Access Compliance Report

Public Rights-of-Way

Intersection ID: 10041752	Main Street: WILKINSON_BV	Cross Street: N/A	Location: NW
ADA ID: 74F9D97F07E7	Ramp Type: BlendTrans1	Initial Pass/Fail: Fail	Overall Compliance: No
		Severity Score: 1.25

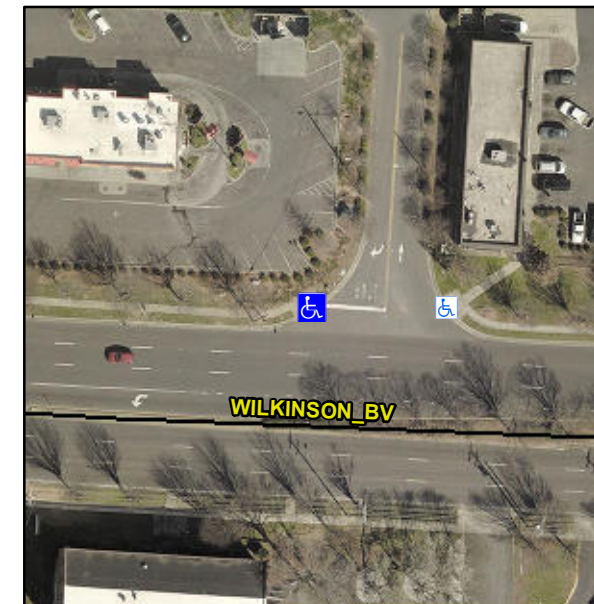
Not Found, R304.5.3

Compliance	Description	Data	Compliance	Description	Data
N/A	Ramp Length (in)	49.0	Yes	BlendTrans Slope (%)	3.9
Yes	Ramp Width (in)	53.0	No	BlendTrans XSlope (%)	2.4
N/A	Flare Type LT	N/A	N/A	Flare Type RT	N/A
N/A	Flare Slope LT (%)	N/A	N/A	Flare Slope RT (%)	N/A
N/A	Flare Traversable LT?	N/A	N/A	Flare Traversable RT?	N/A
N/A	Landing Length (in)	N/A	N/A	DWS Provided?	N/A
N/A	Landing Width (in)	N/A	N/A	DWS Contrast?	N/A
N/A	Landing Slope (%)	N/A	N/A	DWS Length (in)	N/A
N/A	Landing X Slope (%)	N/A	N/A	DWS Full Width?	N/A
N/A	Landing Curb? (Y/N)	N/A	N/A	DWS Offset (in)	N/A
N/A	Shared Landing?	N/A			
N/A	Gutter Ponding?	N/A	N/A	Gutter Slope (%)	N/A
N/A	Gutter Lip Ht (in)	N/A	N/A	Gutter X Slope (%)	N/A
N/A	Painted X Walk1?	No	N/A	Painted X Walk2?	N/A
	X Walk 1 Direction	To E		X Walk 2 Direction	N/A
	X Walk 1 Width (in)	N/A		X Walk 2 Width (in)	N/A
	X Walk 1 Slope (%)	2.7		X Walk 2 Slope (%)	N/A
	X Walk 1 X Slope (%)	4.5		X Walk 2 X Slope (%)	N/A

Remove & Replace Curb Ramp With Two New Directional Ramps or Equivalent.
